**TECHNICAL SERVICE BULLETIN, VIN:
SB-77 RV Door Latch may experience a lock-out condition**

Technical Service Bulletin SB-77 Repair Instructions

TSB102

TriMark Corporation 030-0900 Motor Home Entrance Door Hardware

Part Number and Date Code hardware.

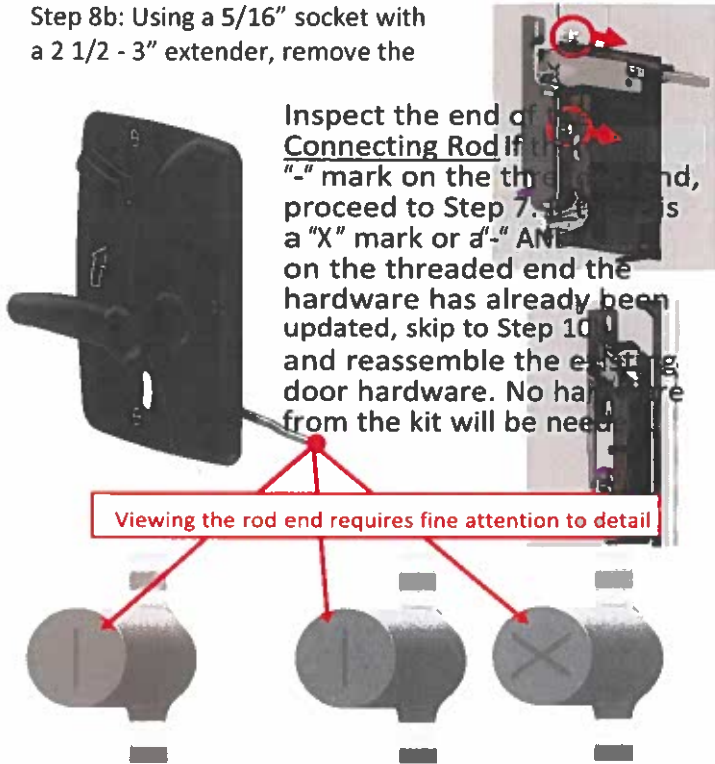
Step 6: Verify the part number stamped on the inside release as **21396** and the date code is between (32U through 52U) or (01V through 24V). If it is, continue to Step 7.

If the part number or the date code is something other than **21396** and date code is not in the range listed above, this door is not included in this campaign, follow Step 10b and reassemble the

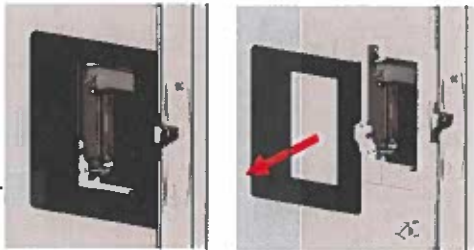
Inspect the end of Connecting Rod for a "-" mark on the threaded end, proceed to Step 7. If there is a "X" mark or a "-" mark on the threaded end the hardware has already been updated, skip to Step 10 and reassemble the existing door hardware. No hardware from the kit will be needed.

Viewing the rod end requires fine attention to detail

Proceed to Step 7

Skip to Step 10b

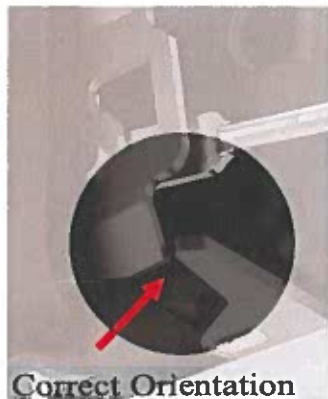
Step 9a: Align the new bracket with the bracket mounting holes in the door and the outside assembly mounting holes, while the outside assembly is aligned with the paint lines. **This is a critical step.**

Step 9b: (Using the old bracket fasteners, unless lost, use new) Install the upper fastener first only turning 2-3 rotations. Then start the lower fastener. Once both are installed a few rotations, check paint alignment and tighten until snug.

Step 9c: Loosen but DO NOT REMOVE the (4) Phillip head screws on the power actuator plate. Slide power actuator/ plate towards the outside edge of the door. Tighten down the (4) screws.

Lower Lock Knob

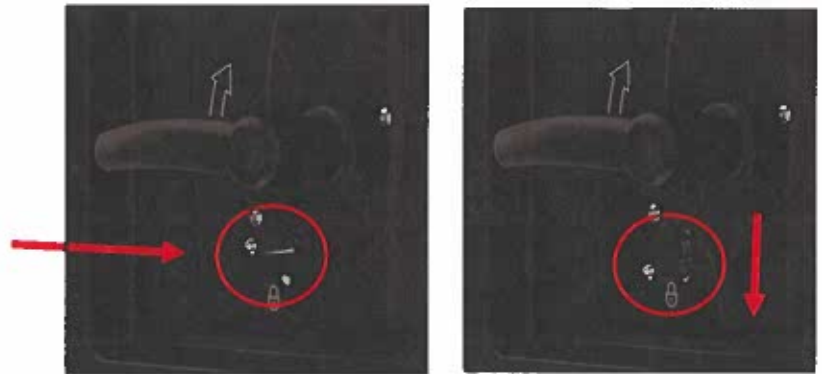
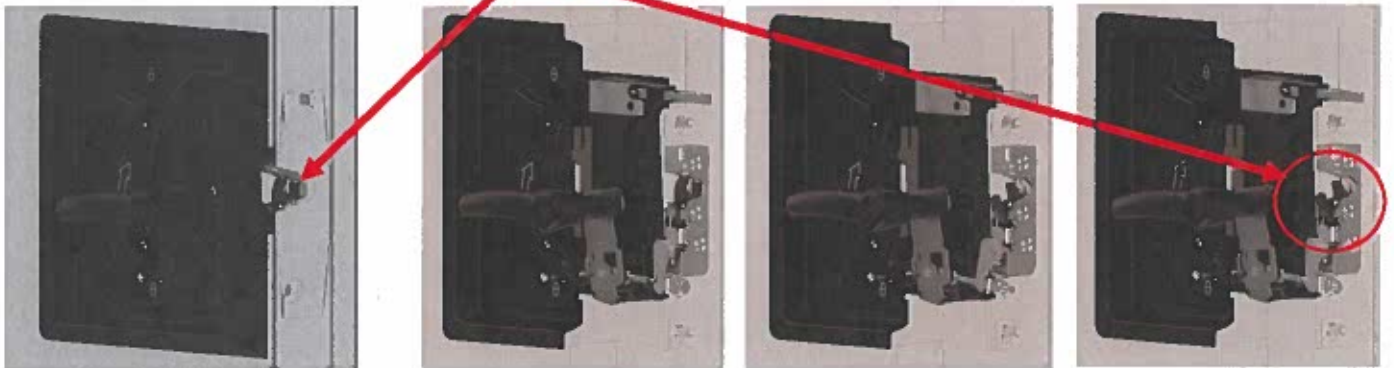
Step 13: **With the door open**, begin Nut adjustment by pushing the inside Lower Lock Knob down into the locked position.

Step 14: Manually close the rotor of the latch while the hardware is still locked from Step 13.

Interior View

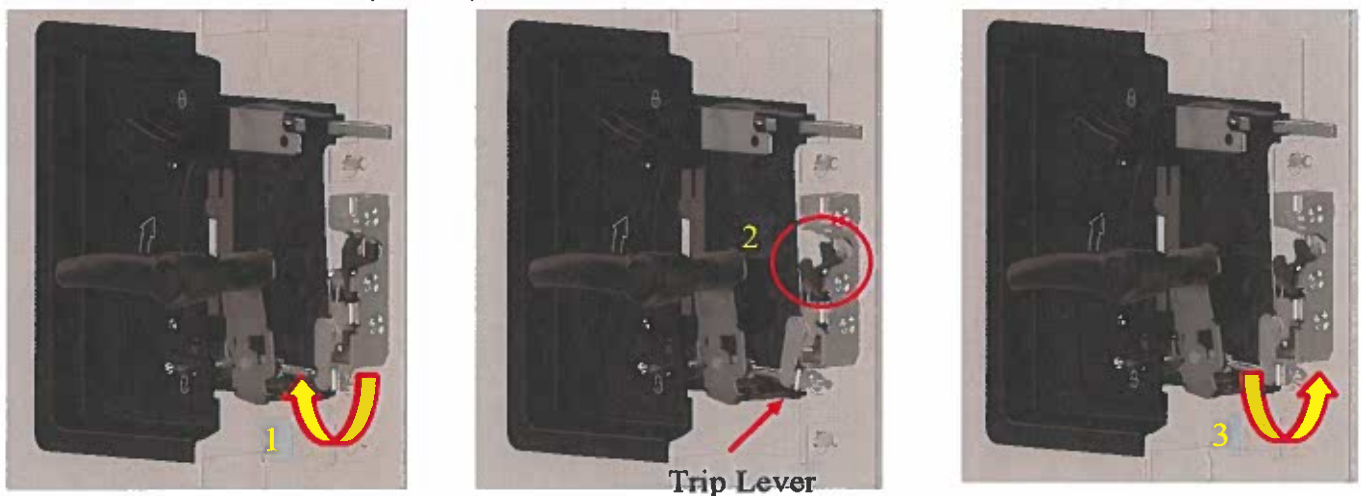
While locked, pull up on the inside handle and continue holding the inside handle up. Using a 7/16" deep well socket, manually (no power), turn the nut clockwise until the latch releases, being sure the nut is contacting the trip lever, and the nut driver is NOT contacting the trip lever. After the latch releases, let go of the inside handle and then turn the nut counterclockwise 1-1/4 to 1-1/2 turns.
